**PUBLIC HEARING/WORKING SESSION III MEMORANDUM**

**PETITIONS #425-18 & #426-18** **156 Oak St., 275-281 Needham St. &, 55 Tower Rd.**

As requested by the Land Use Committee and the Planning Department, the BETA Group, Inc. (BETA), in collaboration with Alta Planning+Design, Inc., submitted an initial peer review (**Attachment B**) of the transportation planning materials and documents of the project, including the Northland Newton Traffic Impact and Access Study (dated October 2018) and the Northland Newton Transportation Implementation Plan (dated October 16, 2018) submitted by the petitioner, (a full list of the material reviewed by BETA is provided in its peer review). Please note that the petitioner responded to a draft of BETA’s review in letter dated January 4, 2019, attached hereto as **Attachment C**.

Prepared by: **BETA GROUP, INC.** and Alta Planning + Design, Inc.  
Prepared for: City of Newton

**FIGURE 2:** TURNING MOVEMENT DIAGRAM FOR 2025 PEAK HOUR CONDITIONS

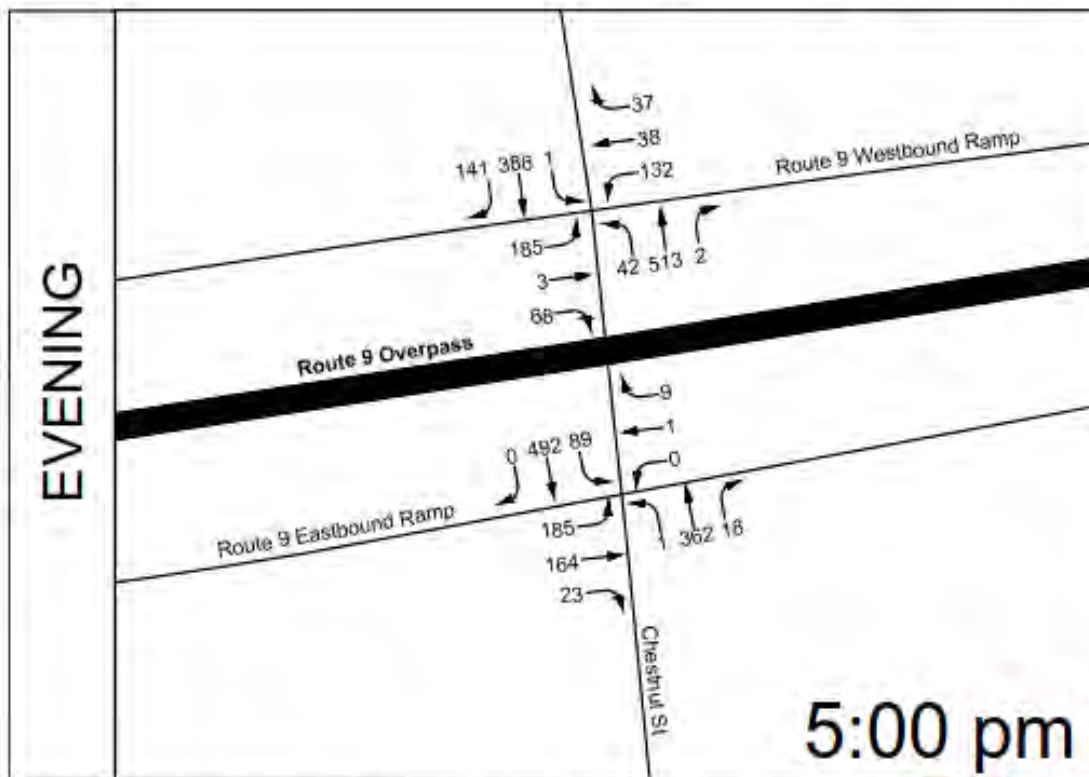
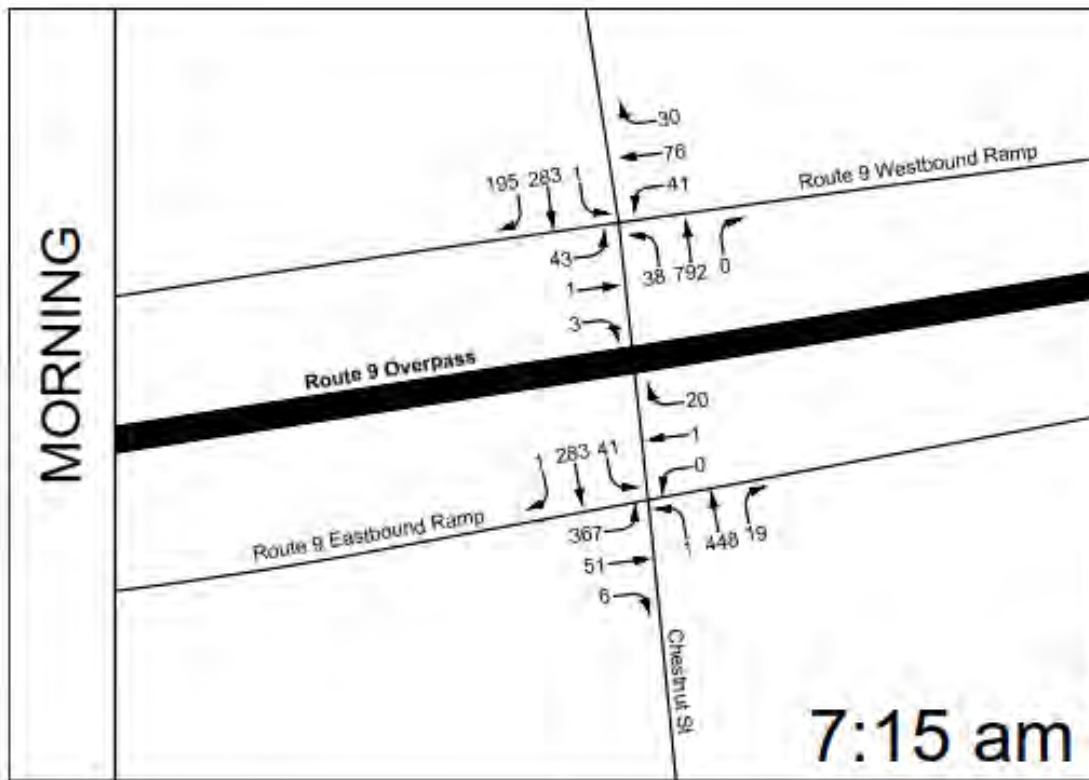
In order to evaluate future operations of the intersection and/or to make design improvements that will be beneficial for future growth as well as present conditions, existing traffic volumes were projected 7 years to a future design year of 2025. (See Figure 2.)

To develop 2025 design year volumes, existing volumes were increased by an annual growth rate based on historical traffic volume data. According to traffic count data for Boylston Street from MassDOT, the ADT has actually decreased in recent years. In order to remain conservative, a
